ADDENDUM NO.   1   DATED   7/19/2016   ADDENDUM NO.        DATED         
 ADDENDUM NO.        DATED        ADDENDUM NO.        DATED

Number	Description
1	Revised Table of Contents; Add Special Provision 907-619-12; Revised Bid Items; Amendment EBS Download Required.

**PROJECT: MP-6043-55(028)/305883301 - Pearl River**

SPECIAL PROVISION NO. 907-619-12

**Detail of Temporary Portable Rumble Strips**

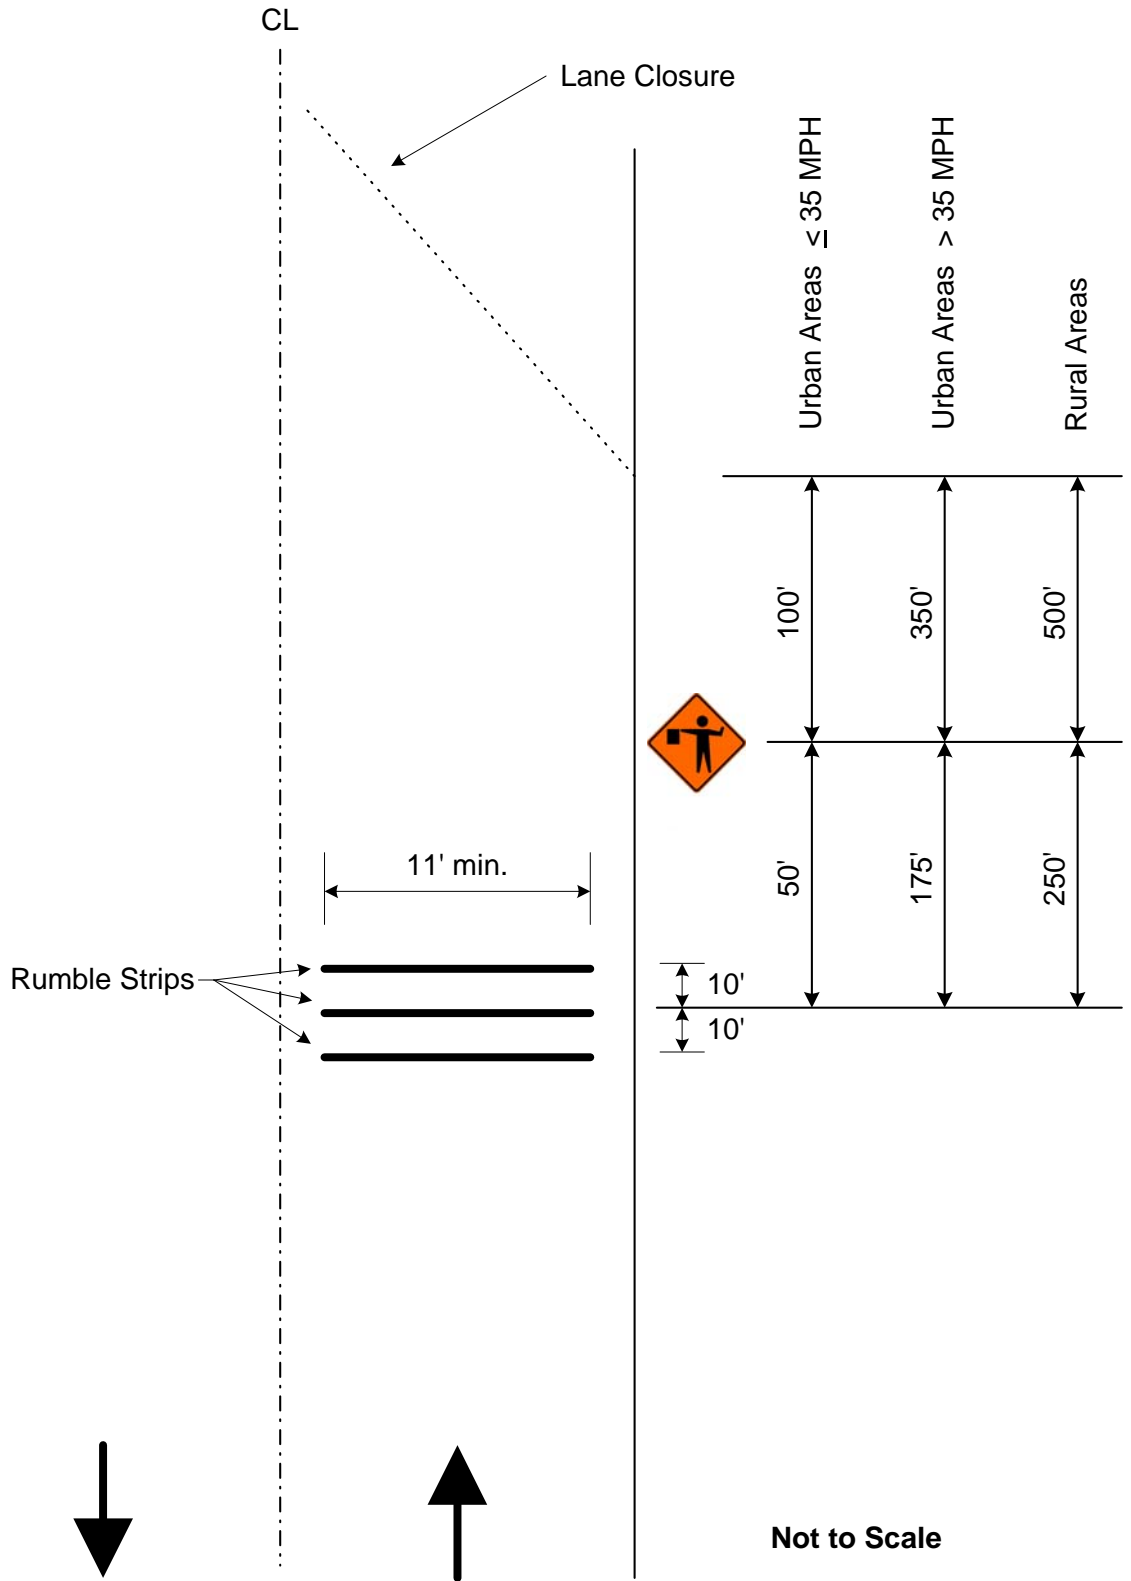
**907-619.02.16--Temporary Portable Rumble Strips.** Temporary portable rumble strips shall be made of engineered polymers and may be composed of interlocking segments or may have a hinge at the midpoint. The rumble strips shall consist of the following:

- capable of being installed without adhesives or bolts,
- have a minimum weight of 100 pounds,
- have a minimum overall length of 11 feet,
- have a minimum width of 12 inches, and
- have a maximum height of 3/4 inch.

Temporary portable rumble strips shall be installed in accordance with the attached details, or as directed by the Engineer.

**907-619.03.12--Temporary Portable Rumble Strips.** Temporary portable rumble strips shall be placed at locations shown on the traffic control plans, attached drawing, or as directed by the Engineer. The rumble strips shall be removed when lane closures are removed, relocated when lane closures are relocated, or as directed by the Engineer.

A minimum of three (3) temporary portable rumble strips shall be arranged in an array. The spacing of temporary portable rumble strips in each array shall be on 10-foot centers. The rumble strips shall be regularly monitored and maintained to ensure they stay in place under traffic.
